Model: Russian-C2 ADF (DF75) Date			e: 4-Jul-02		No.: MB386001	
Modified Article: Magnet Catch					by: S.	Tomoe
From: Technical Services sec. Service Planning Dept.						
Reason for	☐ Parts catalog correction			ange	☐ To n	neet standards
Modification: ☐ To facilitate assembly ☐ To improve		e reliability	(	)		
	☐ Part standardization	☐ Othe	r

### Modification Bulletin

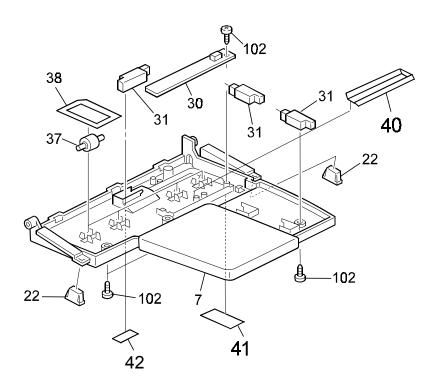
The following has been changed due to standardization with the Model A-C2 ADF.

Old part number	New part number	Description	Q'ty	Int	Page	Index	Note
B3796063	G5646076	Decal – Exposure Glass	1-1	X/O	3	19

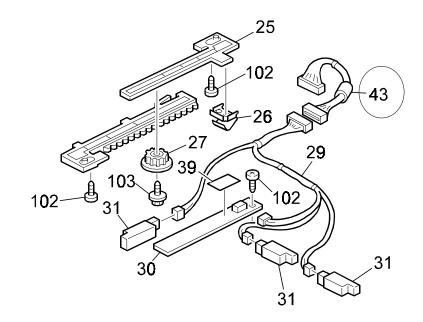
To increase the latitude against electromagnetic interference when this ADF is installed on the Model U-C1, a Relay Harness has been added.

Old part	New part	Description	Q'ty	Int	Page	Index	Note
number	number						
A8595702	B4895715	Original Tray Harness	1-1	X/O	5	29	
	B4895713	Relay Harness – Original Tray	0-1	7/0	5	43

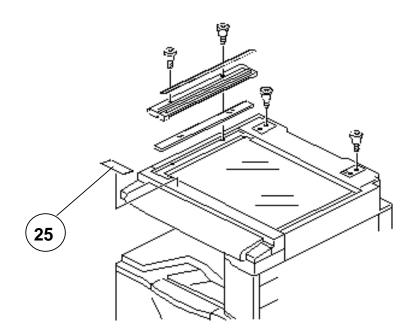
The following decal has been added to prompt the operator to clean the exposure glass to ensure black lines do not appear on the copy.

Old part	New part	Description	Q'ty	Int	Page	Index	Note
number	number						
	G5646087	DECAL:EXPOSURE GLASS:MACHINE OR COP	0-1	X/O	3	25
